PLN-2021-17560-APPEAL

Project Title: Valadao – Subdivision Appeal
Address: 1820 Pickett Rd., McKinleyville, CA 95519
Assessor's Parcel # 510-381-021-000
Record Number: PLN-2021-17560-APPEAL
Board of Supervisors File Number: BAI-23-1593
planningclerk@co.humboldt.ca.us

We hereby appeal the November 16, 2023 decision of the Humboldt County Planning Commission, regarding the Valadao Subdivision. We ask the Board of Supervisors to:

Exhibit II

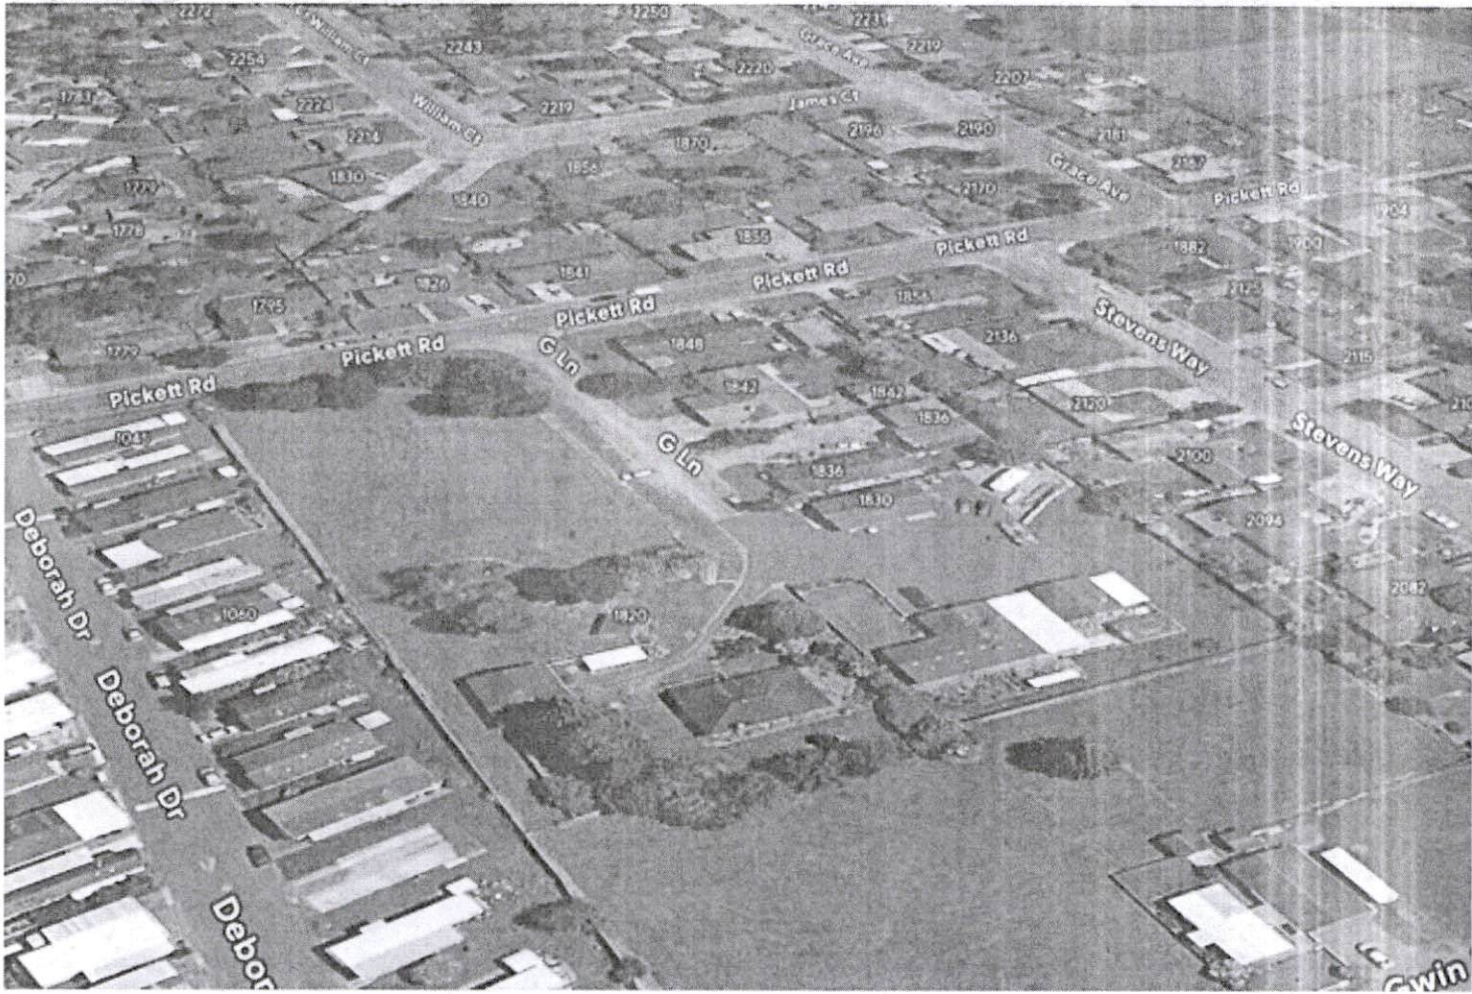
- f) According to the General Plan, Design Review can be used to ensure compatibility with neighborhood character. **(See Exhibit II for a Google satellite image.)**

- The surrounding area is *one-story* single-family homes, each on 1/3 acre.

- One single-story, quiet, well maintained, Senior mobile home park is adjacent to the parcel
- The proposal is 60 giant Two-Story Apartments on 2.11 acres. Density—29 units per acre

Exhibit VI

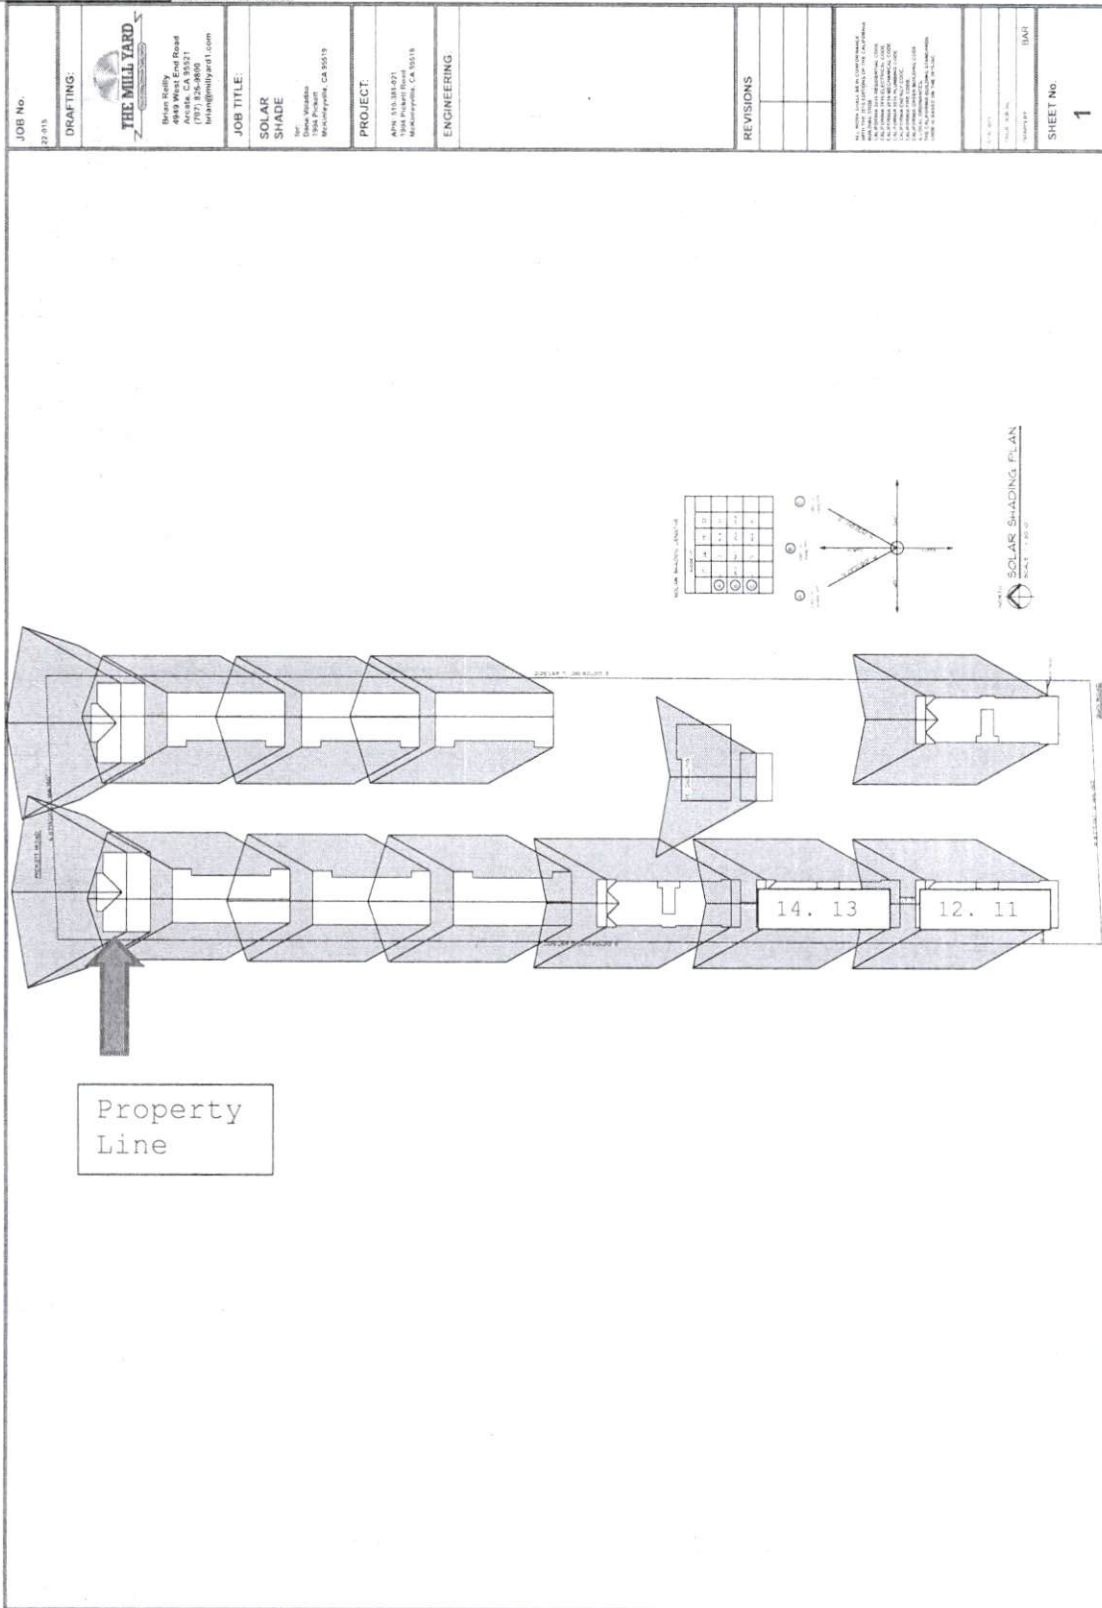
However, given the Applicant did not do that, and is instead proposing gigantic 90-foot, *two-story* buildings facing *east*, which are only 10 feet apart, he simply cannot meet the solar access requirement. (*See Exhibit VI.*) Because, except for the existing house (Lot 8) and the initial buildings in each row of apartments (Lots 7, 10, and 11), it is mathematically impossible for two-story buildings 10 feet apart to comply to the code. (That is why most buildings in Humboldt County are one-story.) The "Solar Shade Plan" Exhibit prepared by the Mill Yard proves this out. (*See Exhibit VI.*)
